# PROPOSED WAREHOUSE DEVELOPMENT

**246 Miller Road, Villawood  
Riparian Management Advice**

SLR Ref: 630.30024-R01  
Version No: -v1.1  
June 2020

Project No  
190201  
Drawing No  
CD - A 163  
Issue  
P4

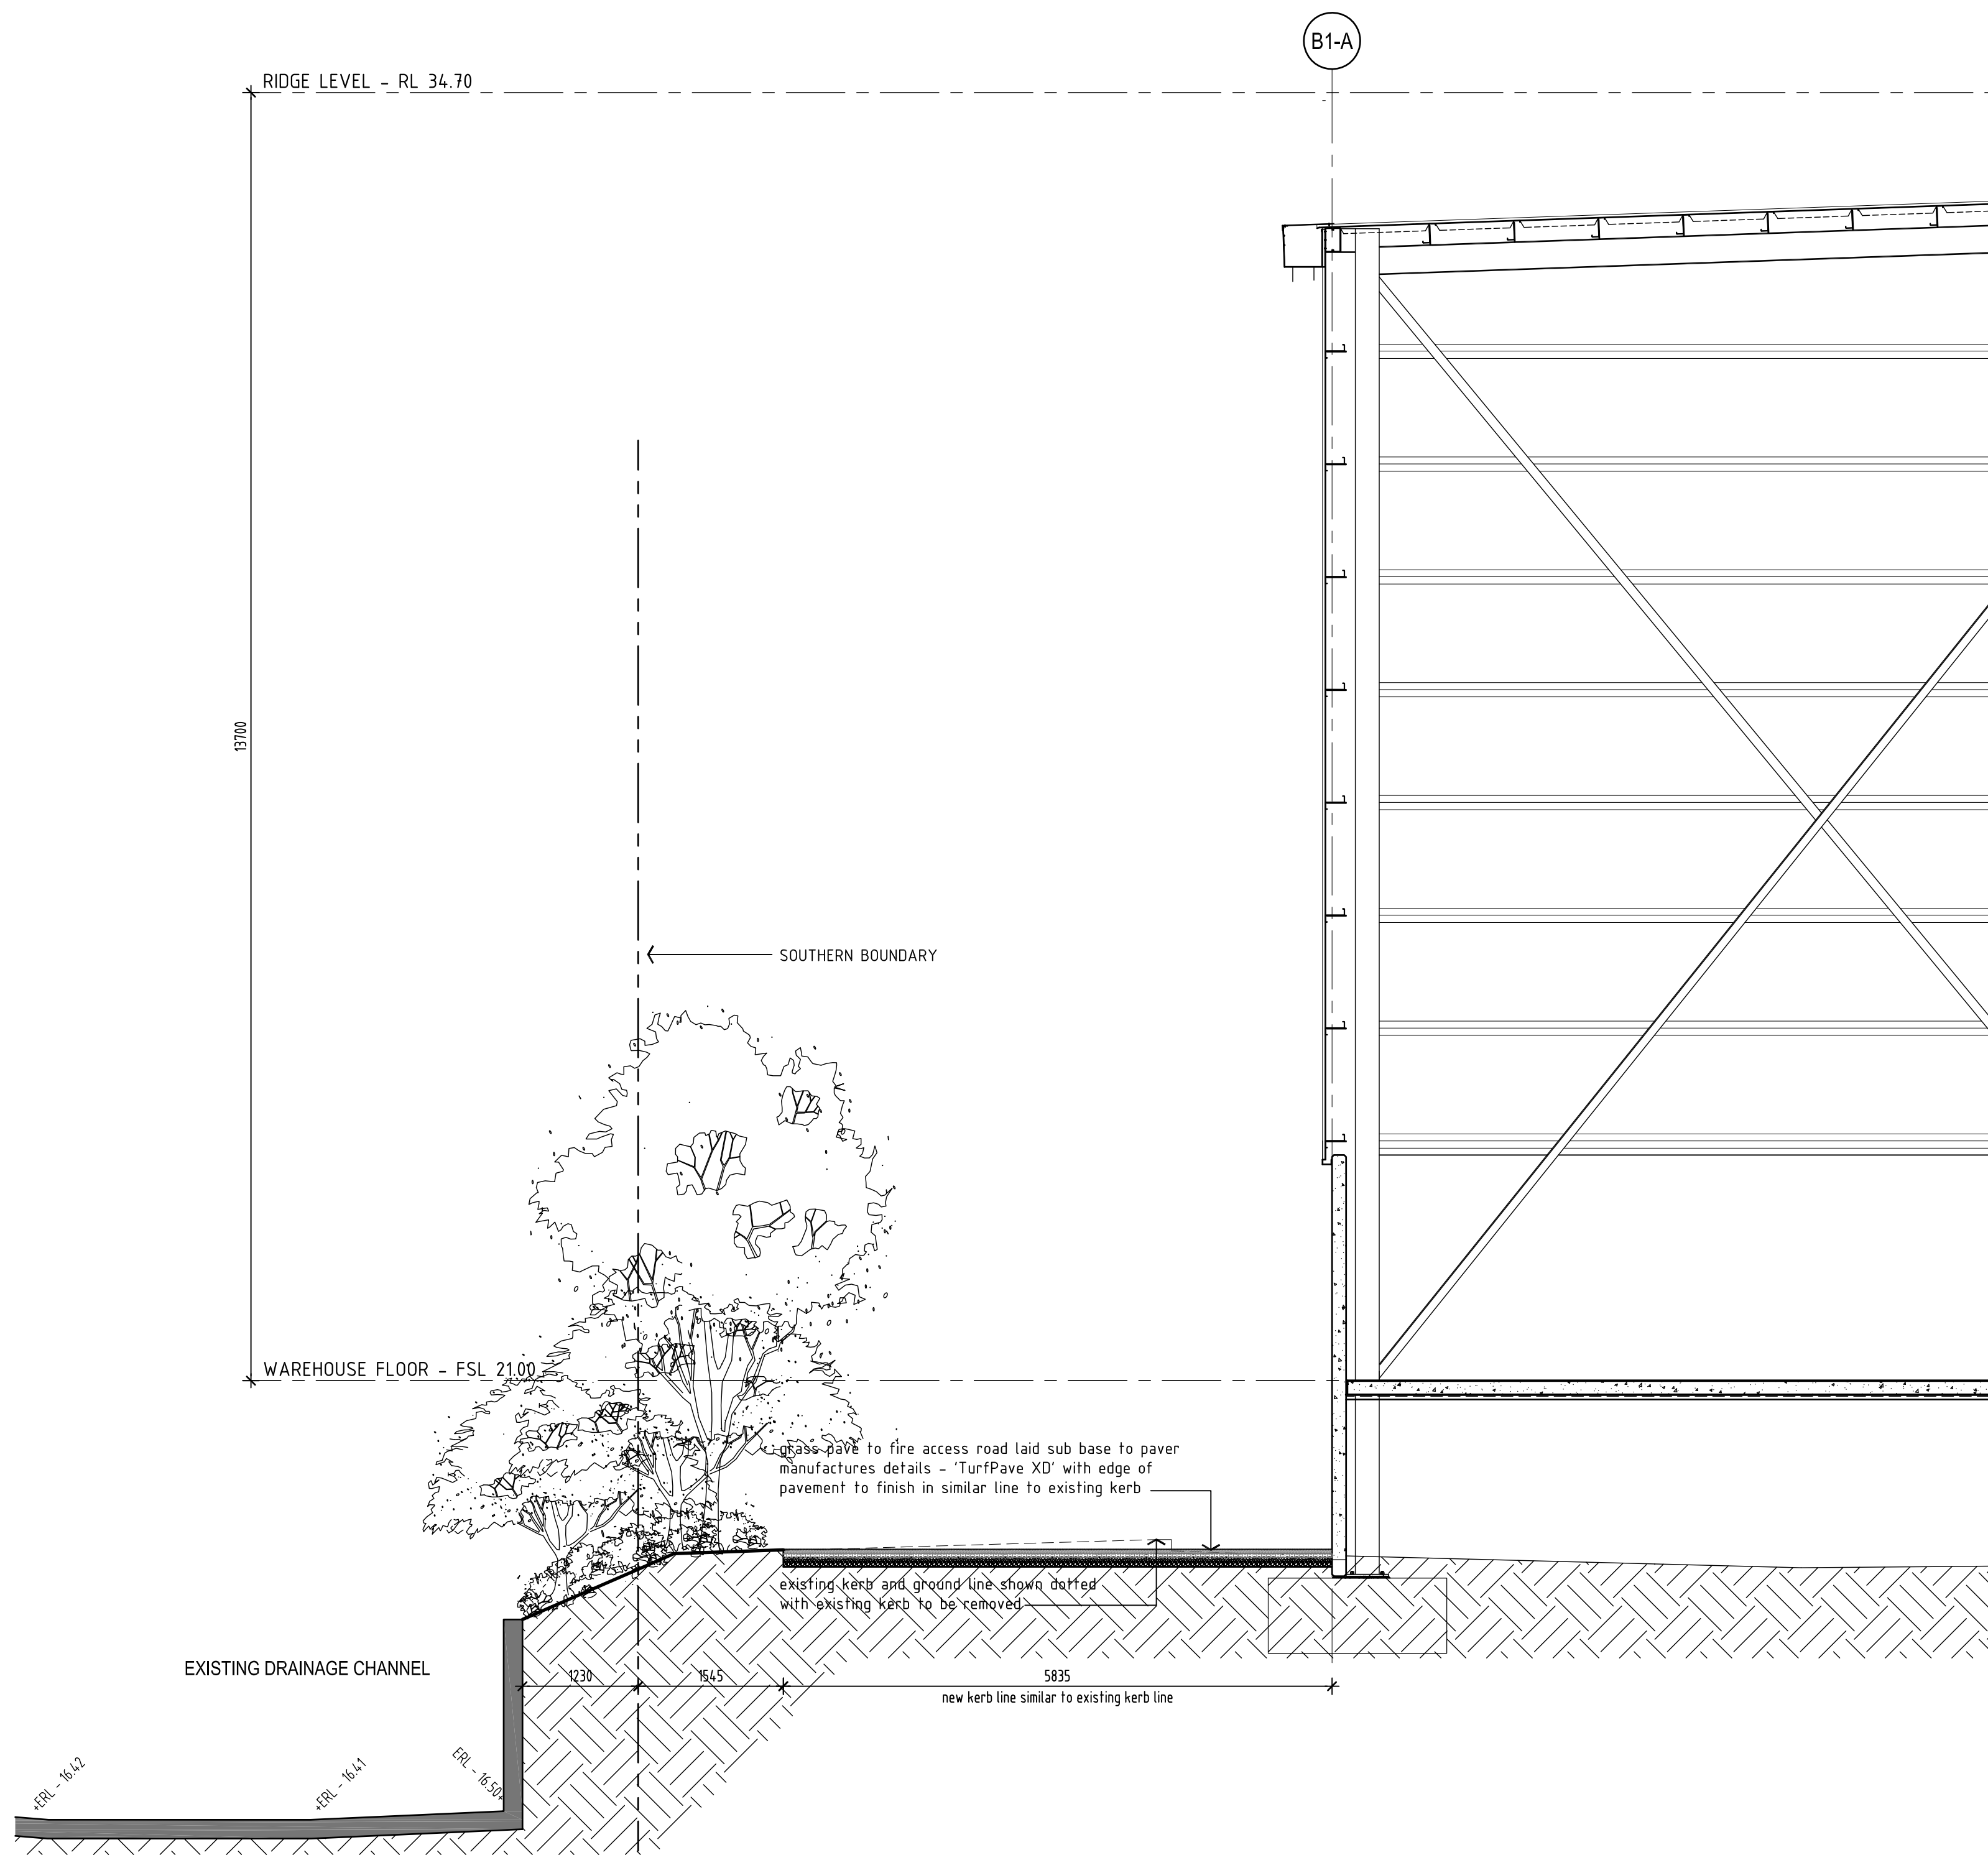
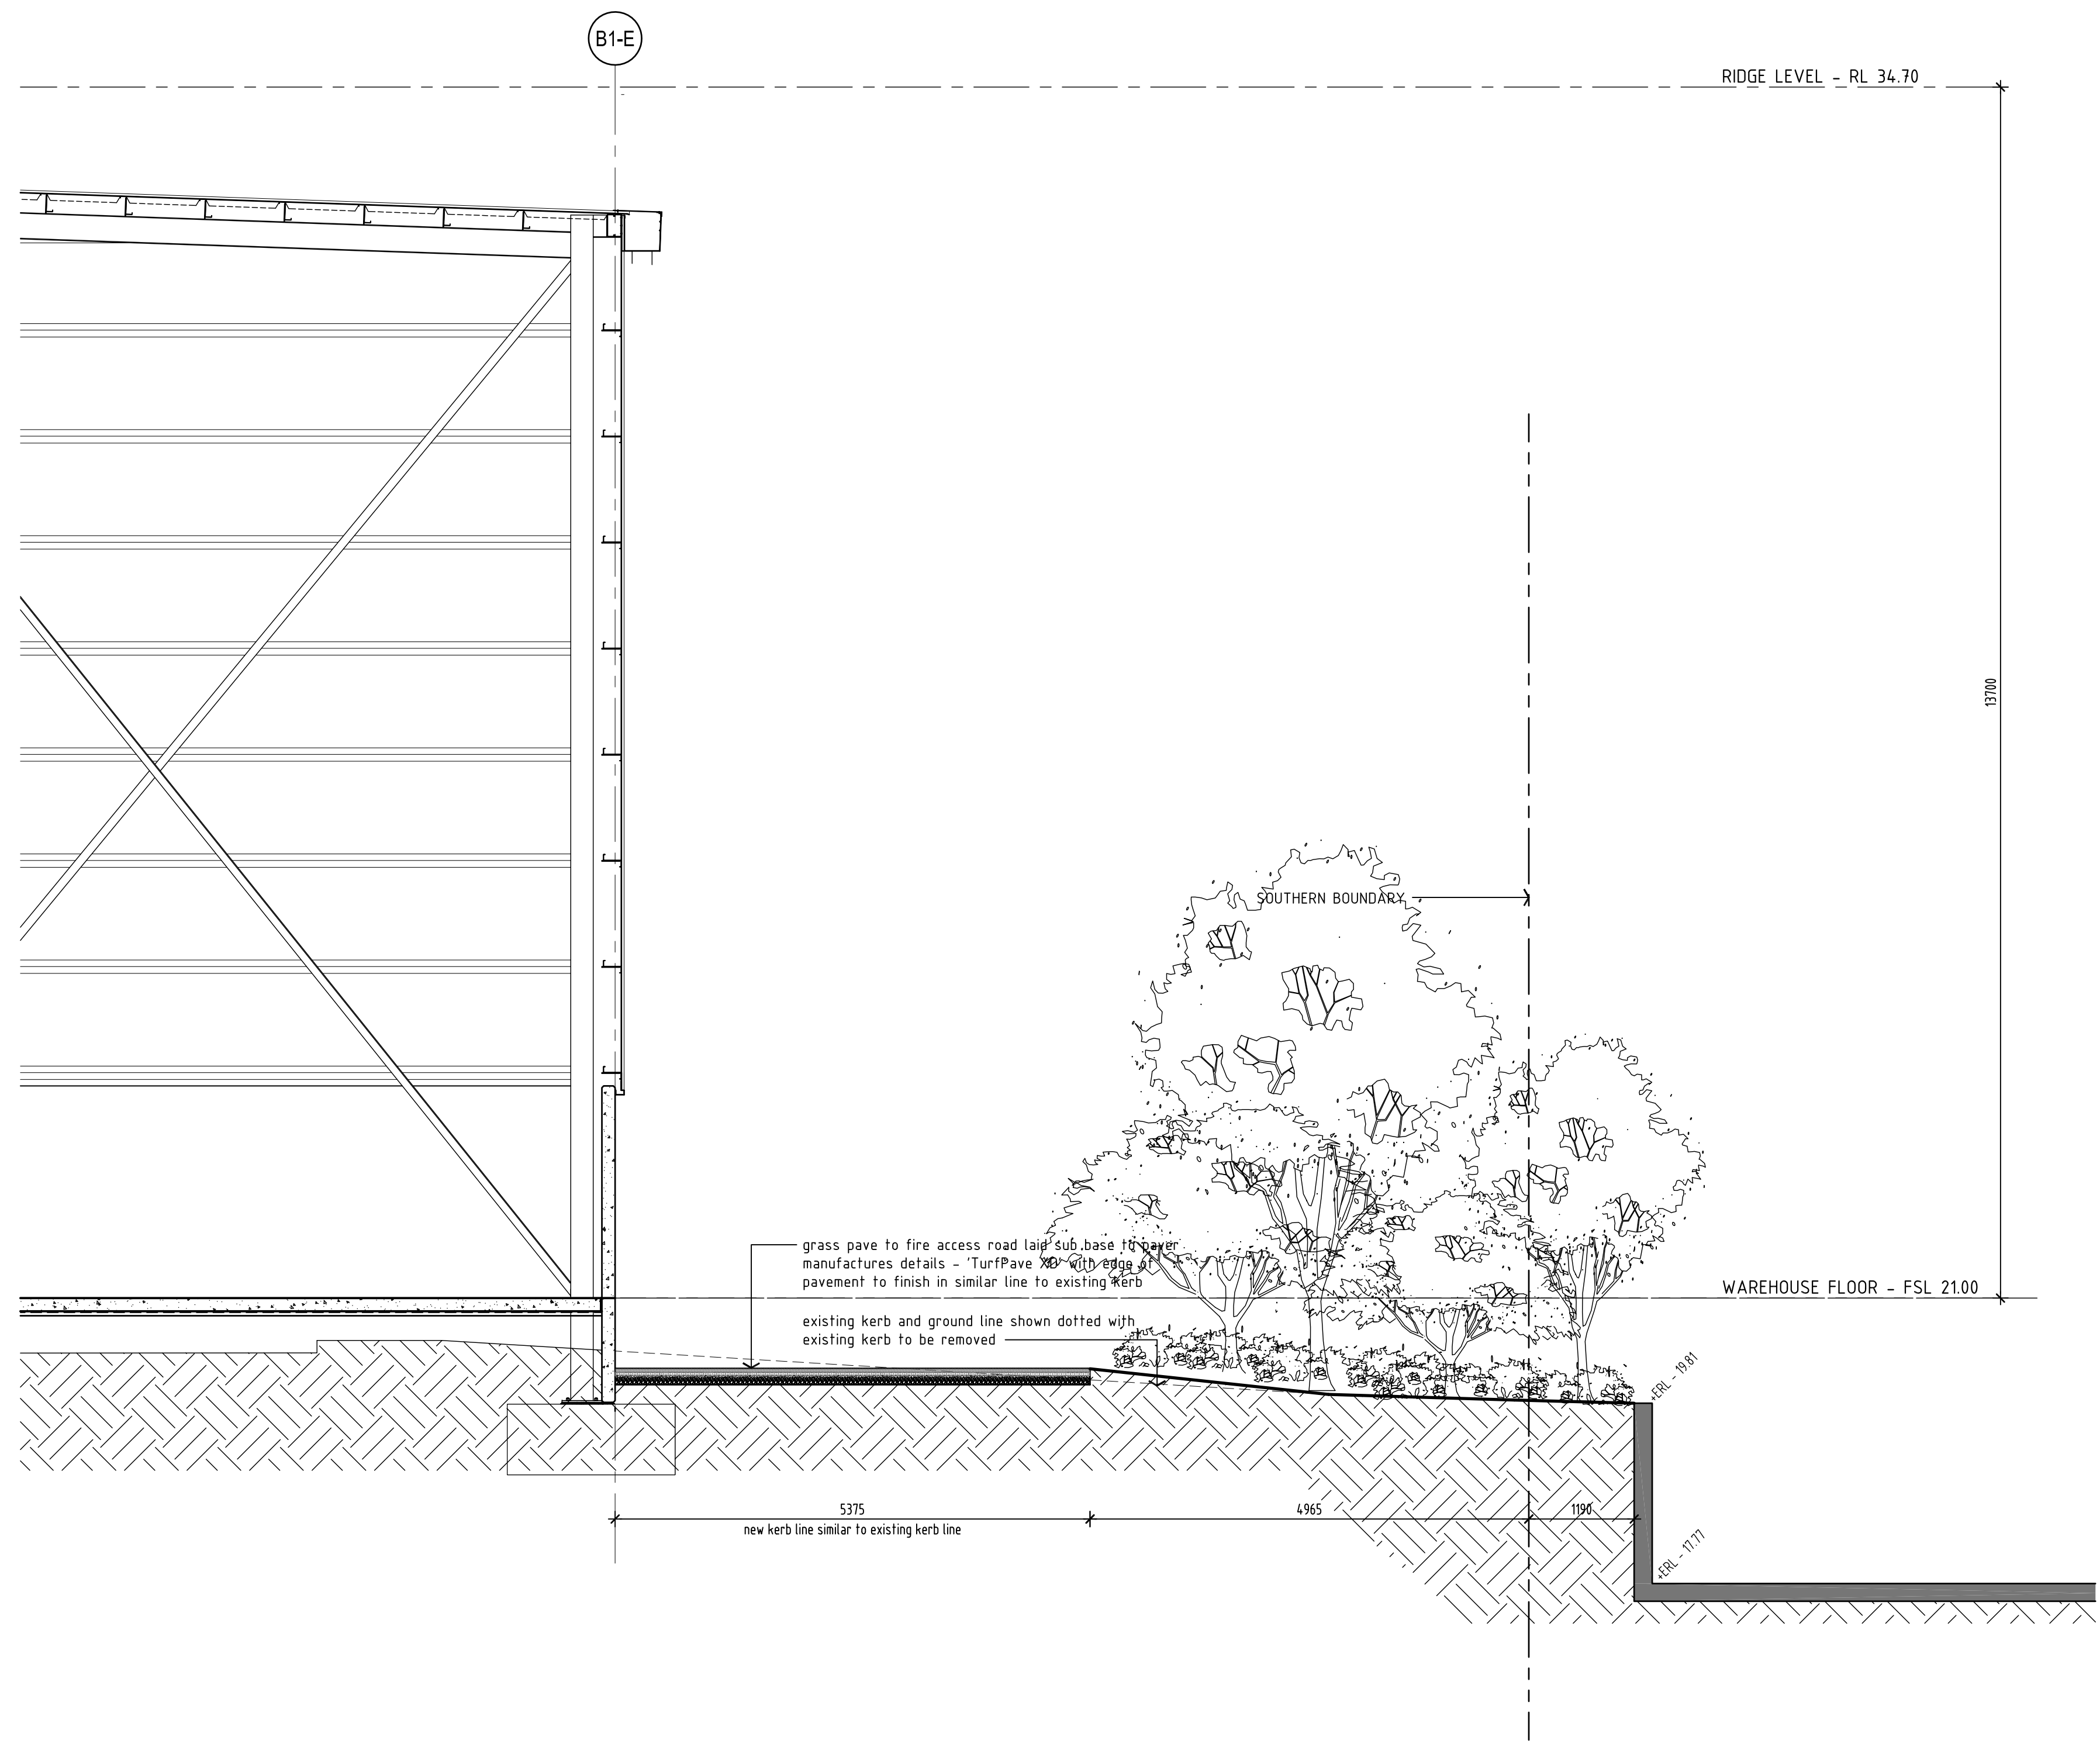
- Fire truck access road, which is a mandatory requirement to allow access for fire fighting vehicles. The amended proposal provides for a 5.675 m wide paved road, constructed of a permeable material (TurfPave XO).
- Vegetated Riparian Zone – between the fire access road, the southern site boundary and from the site boundary to the edge of the channel. This strip of land will be recontoured, with clean soil placed and planted with a selection of locally indigenous flowering plants (small trees, shrubs and groundcovers).

The total width of the proposed riparian zone extends from the top-of-bank of the channel to the edge of the proposed warehouse building with a total width of 8.6 m to 11.5 m (see **Appendix A**).

- Creates a vegetated riparian zone (or VRZ), consistent with NRAR guidance for waterfront land and with Clause 2.7 of the DCP, although it is acknowledged that the recommended width of the VRZ will not be 15 m as per the DCP or 10 m wide as per NRAR guidelines; the space limitations of the site and the design requirements of the proposed warehouse, as well as the requirements for a fire access road, do not allow a riparian corridor of greater width;

- Amend landscape plan to provide detailed drawing of proposed riparian planting area (i.e. vegetated riparian zone) along southern boundary;
- Create a 'vegetated riparian zone' between fire access road and channel bank, with imported clean substrate (sandy loam VENM soil or crushed sandstone) and plantings of local indigenous species; seek to maintain or rehabilitate the zone with fully structured native vegetation, in accordance with NRAR (2018) guidance;
